Our Ref: J27035

04 February 2010

**ENVIRONMENTAL IMPACT ASSESSMENT FOR THE PROPOSED ESKOM NUCLEAR POWER STATION AND ASSOCIATED INFRASTRUCTURE: COMMENTS REGARDING THE ESKOM NUCLEAR-1 ENVIRONMENTAL IMPACT ASSESSMENT**

Diagram 1

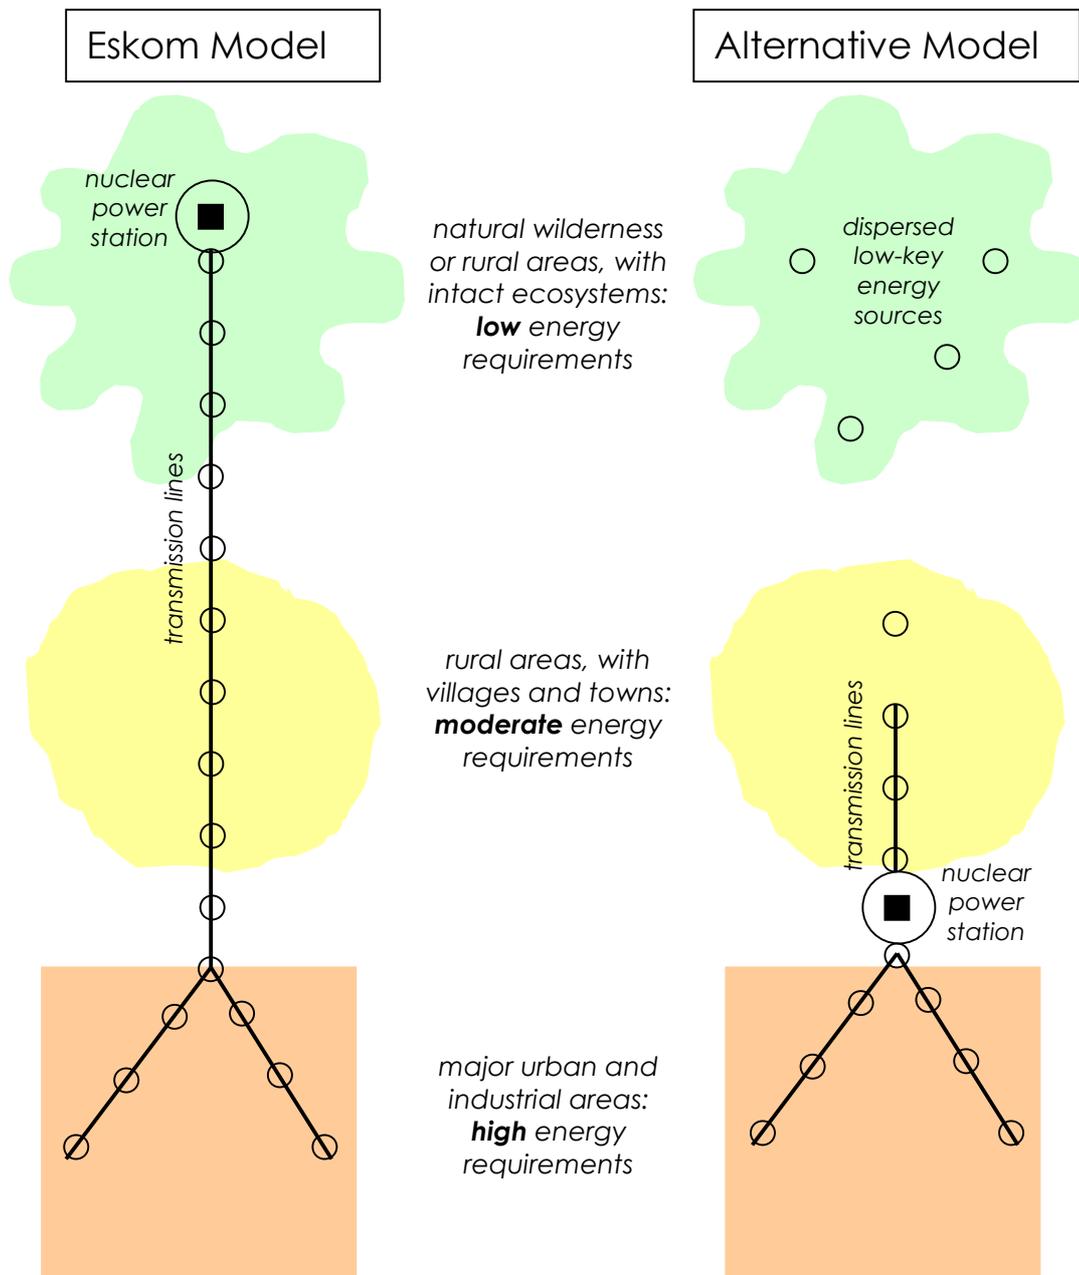
A major problem appears to be the **separation of planning** for power stations on the one hand and the transmission lines on the other. Diagram 1, attached below, compares the Eskom model to an alternative model with social, ecological, economic and strategic benefits.

The diagram is based on the principle that industrial-related infrastructure should be located in areas that are already industrialized, where it is needed and where it will have the least impact, rather than in pristine areas with intact or sensitive ecosystems or scenic landscapes. In addition, natural or rural areas, with low energy requirements would ideally make use of more localised, low-key forms of energy generation, such as solar energy. Besides saving on transmission lines, the strategic and environmental benefits should be clearly evident.

**Characteristics of Eskom Model:**

- Power stations located in pristine areas, where not needed;
- Greater social, ecological and visual impacts of transmission lines;
- Lengthy, economically costly transmission lines;
- Lower efficiency due to energy loss;
- Longer transmission lines strategically more vulnerable;
- Less incentive for alternative energy sources.

**Characteristics of Alternative Model:**

- Power stations located in degraded areas, close to areas where needed;
- Reduced social, ecological and visual impacts;
- Shorter, less costly, lower maintenance transmission lines;
- Greater energy distribution efficiency;
- Less transmission lines have lower security risk;
- Dispersed alternative energy sources in rural/wilderness areas.

Whilst the model you have proposed has merit, it is critical to firstly consider locations that are **technically** suitable for the construction of an NPS, and then to consider other factors. Thus, once the Corridors (the Cape Corridor, the Cape Peninsula Corridor and the Southern Grid Corridor) where strengthening is required were identified, the NSIP investigated strategic criteria that influence the technical suitability of the sites for a Nuclear Power Station. This was one of the main functions of the NSIP and is the reason for the initial identification of five sites.

The choice of sites for the proposed NPS is firstly based on proximity to the centres where power is required. Thus all sites are situated in the Western and Eastern Cape provinces, which enables shorter transmission lines than would be required if power were to be transmitted from a coal-fired power station in the northern parts of the country.

The location of a Nuclear Power Station is based on a number of criteria, based on technical, safety, security and other considerations. The factors that were considered for the location of the initial five sites in the Nuclear Site Investigation Programme (NSIP), (included as Appendix D of the Final Scoping Report), include the following:

- Availability of water for cooling;
- Geological suitability and the occurrence of mineral deposits;
- Seismicity / seismic hazard;
- Distance from urban populations;
- Rural population;
- Political boundaries and security zones;
- Areas of national conservation importance;
- Security areas; and
- National physical development and decentralisation policies.
